August 28, 2001  
NUH03-01-1722

**Subject:** Supplemental Thermal Calculations and Supporting ANSYS Input Files for Amendment No.5 of NUHOMS® Certificate of Compliance No. 1004 for Dry Spent Fuel Storage Casks

## Supplemental Thermal Calculations

**Figure 1 Closed cavity convection model**

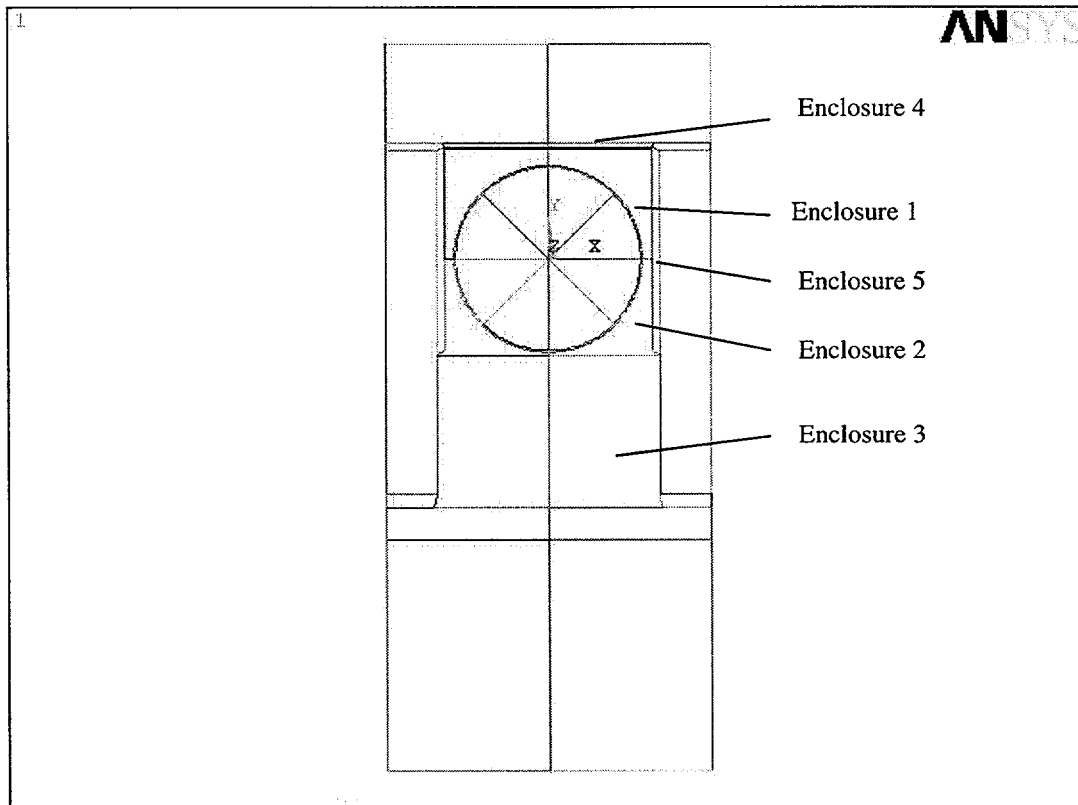
**Item 4: Provide additional description of “Closed Cavity Convection” modeling technique to include graphical representation of the zones used for the model and electronic files of any computer models used.**

In order to evaluate the thermal effect of closed cavity convection of air within the HSM on DSC shell temperatures, the HSM cavity surrounding the DSC is divided into 5 enclosures as shown in Figure 1 below.

The bottom border of the bottom inclined enclosure 2 - the free surface - can be considered as solid for mean temperature evaluation. Interference of flows in enclosures 1 and 2 is expected to be negligible, since enclosure 1 is heated from below and enclosure 2 from the top.

Convection within enclosure 3 is conservatively neglected, since the rectangular annulus heated from the top does not experience noticeable free thermal convection. Convection and conduction in the air are combined into an effective thermal conductivity value for each enclosure, based on temperature difference, geometry and flow regime. The analysis considered the geometry and thermal convection conditions for each particular enclosure. Irregular enclosures 1 and 2 were represented by inclined ( $45^\circ$  and  $-45^\circ$ , respectively) flat rectangular annuluses. Inclination correction coefficients were applied.

Effective thermal conductivity of the air within closed cavity convection enclosures is evaluated by hand calculations. Excel spreadsheet (32p\_Black\_Vent\_Conv.xls) and copies of ANSYS HSM and DSC input files (BL\_Vent\_Conv\_32PT.txt, sd32\_blk\_alt\_it2.txt) are provided in the attached CD.
